DRAFT FINAL WELL ABANDONMENT PLAN

INHIBITED RED FUMING NITRIC ACID (IRFNA) DISPOSAL SITE (SEAD-13)
SENECA ARMY DEPOT ACTIVITY

Subject: Draft Remedial Action Operations Plan
Inhibited Red Fuming Nitric Acid (IRFNA) Disposal Site (SEAD-13)
Seneca Army Depot
Romulus, New York

**Figure 2-1
Schedule for SEAD-13 Well Decommissioning
WELL ABANDONMENT PLAN FOR SEAD-13
SENECA ARMY DEPOT ACTIVITY**

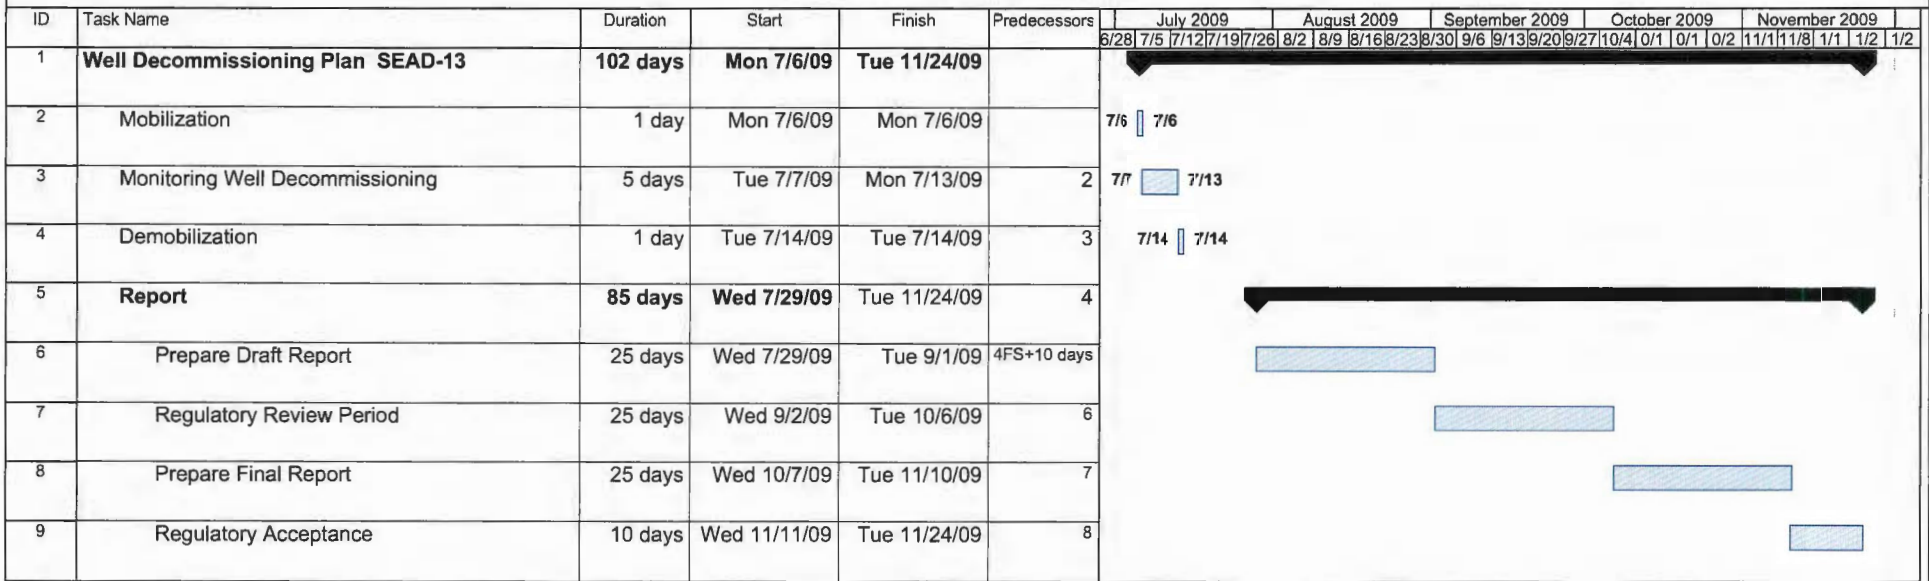
Comment 4: A detailed schedule indicating the timetable for initiating and completing the proposed tasks has not been provided in the RAOP. A timeline or schedule which includes proposed mobilization/demobilization, work completion periods, and report finalization should be included. Revise the RAOP to include a detailed schedule indicating the proposed mobilization/demobilization, work completion periods, and report finalization.

Response 4: A schedule has been prepared for the well abandonment tasks including decommissioning of the groundwater monitoring wells and preparation and submittal of the final report. The schedule will be incorporated into the subject document as Figure 2-1.
